SB-10054928-8717**FORD:**

2011-2014 F-150

ISSUE

Figure 1 - Article 14-0014

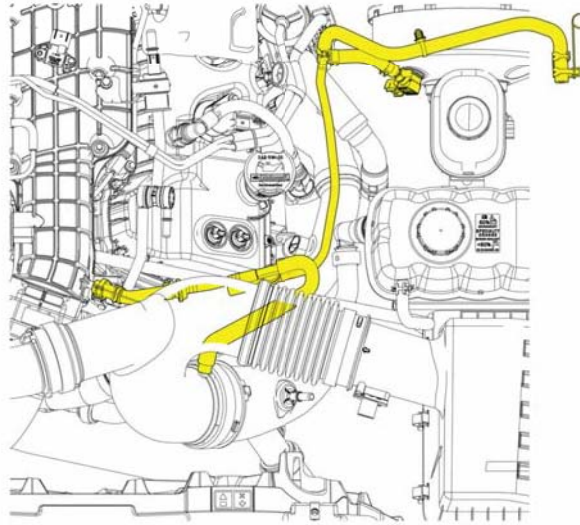
1. Is the vehicle equipped with a heater in the thermostat housing? Refer to Workshop Manual (WSM), Section 303-03.
 - a. Yes - remove and discard the heater and cord. Refer to WSM, Section 303-03. Proceed to Step 2.
 - b. No - proceed to Step 2.
2. Remove the left hand (LH) Turbocharger. Refer to WSM, Section 303-04.
3. Install the Block Heater Kit.
 - a. Installation instructions are provided in the kit.
4. Install the LH Turbocharger. Refer to WSM, Section 303-04.
5. Change the engine oil and oil filter.
6. Replace the Positive Crankcase Ventilation Valve (PCV) . Refer to WSM, Section 303-08.
7. Determine the vehicle build date. Refer to WSM, Section 100-01.
 - a. a. If the vehicle build date is on or before 10/24/2011, proceed to Step 7.
 - b. b. If the vehicle build date is after 10/24/2011, proceed to Step 11.
8. Remove and discard brake booster vacuum hose. (Figure 1)

Figure 2 - Article 14-0014

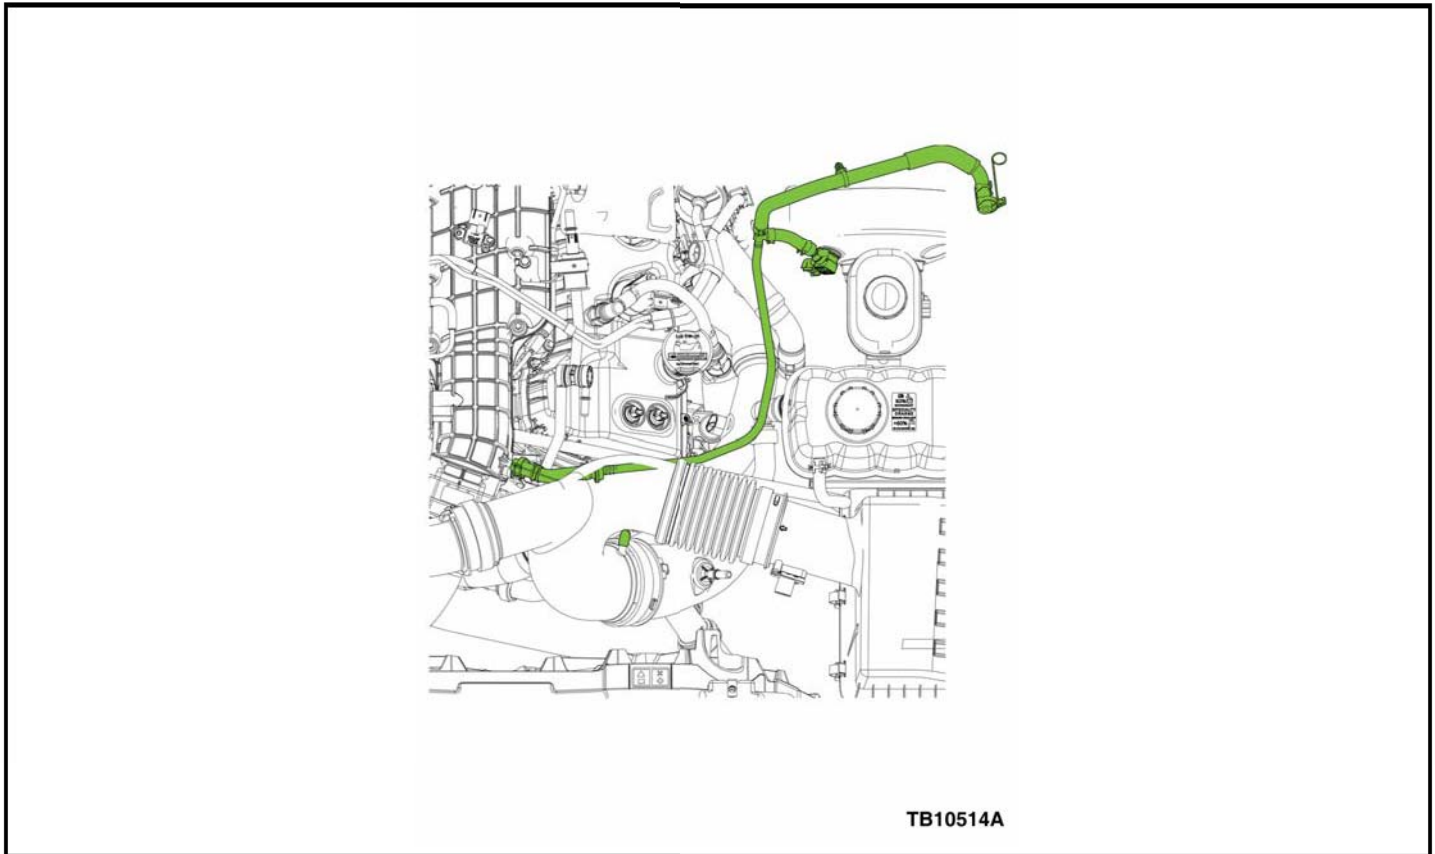
9. Install the new brake booster vacuum hose. (Figure 2)

10. Install the cap on the air intake. (Figure 2)
11. Reprogram the Anti-lock Brake System (ABS) Module to the latest calibration using IDS release 88.02A and higher. Calibration files may also be obtained at www.motorcraft.com.
12. Reprogram the powertrain control module (PCM) to the latest calibration using IDS release 88.02A and higher. Calibration files may also be obtained at www.motorcraft.com.
13. **NOTE:**
PLEASE ADVISE THE CUSTOMER THAT THIS VEHICLE IS EQUIPPED WITH AN ADAPTIVE TRANSMISSION SHIFT STRATEGY WHICH ALLOWS THE VEHICLE'S COMPUTER TO LEARN THE TRANSMISSION'S UNIQUE PARAMETERS AND IMPROVE SHIFT QUALITY. WHEN THE ADAPTIVE STRATEGY IS RESET, THE COMPUTER WILL BEGIN A RE-LEARNING PROCESS. THIS RE-LEARNING PROCESS MAY RESULT IN FIRMER THAN NORMAL UPSHIFTS AND DOWNSHIFTS FOR SEVERAL DAYS.
